<b>Subject:</b> <b>GRINDING NOISE WHEN OPENING AND / OR CLOSING TRUNK LID</b>	<b>Bulletin No:</b> 09-029/16
	<b>Last Issued:</b> 04/29/2016

2016 Mazda6 vehicles with VINs between JM1 GJ \*\*\*\*\* 400001 - 401811 (produced before December 11, 2014)

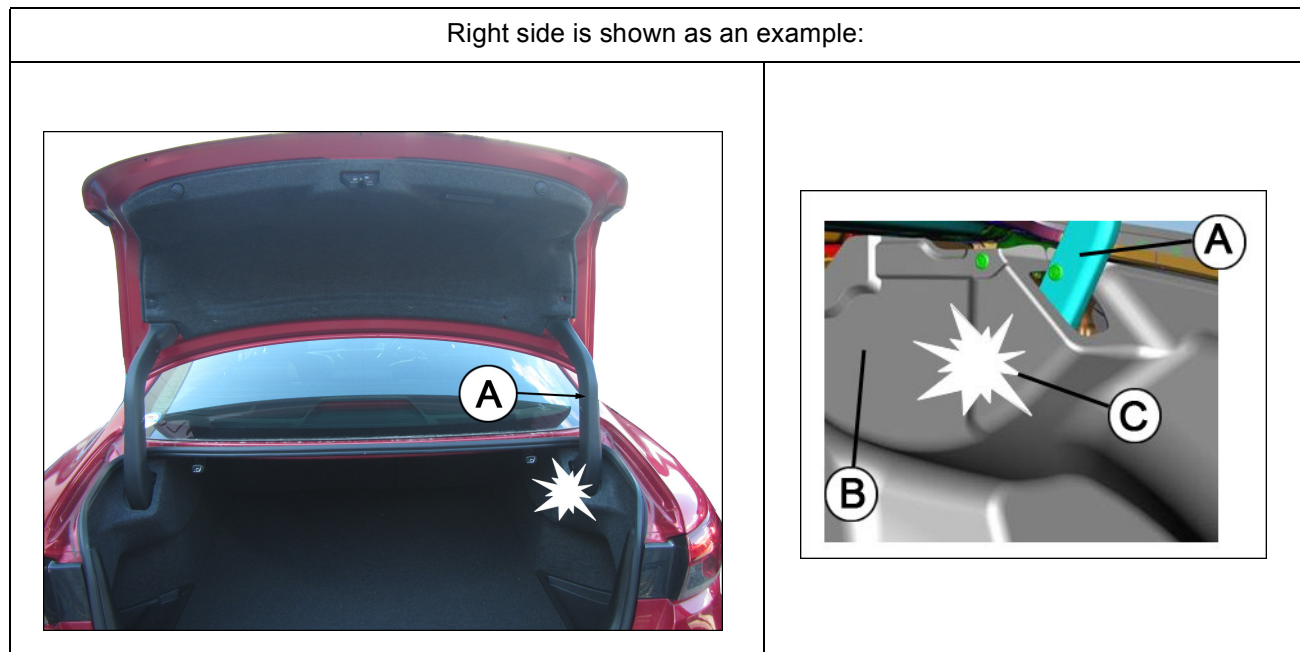
Some vehicles may exhibit a grinding type noise (C) from the trunk lid hinge (A) (one or both sides) when opening and/or closing the trunk lid. The noise may be caused by the trunk lid hinge cover (A) making contact with the trunk side trim (B).

1. Verify customer concern.
2. Replace the trunk hinge cover(s). Refer to MS3 online "TRUNK LID REMOVAL/INSTALLATION".

Part Number	Old Part Number	Description	Qty.	Notes
G46G-68-8W5A	G46G-68-8W5	COVER(R), TRUNK SIDE	1	Right side
G46G-68-8W6A	G46G-68-8W6	COVER(L), TRUNK SIDE	1	Left side
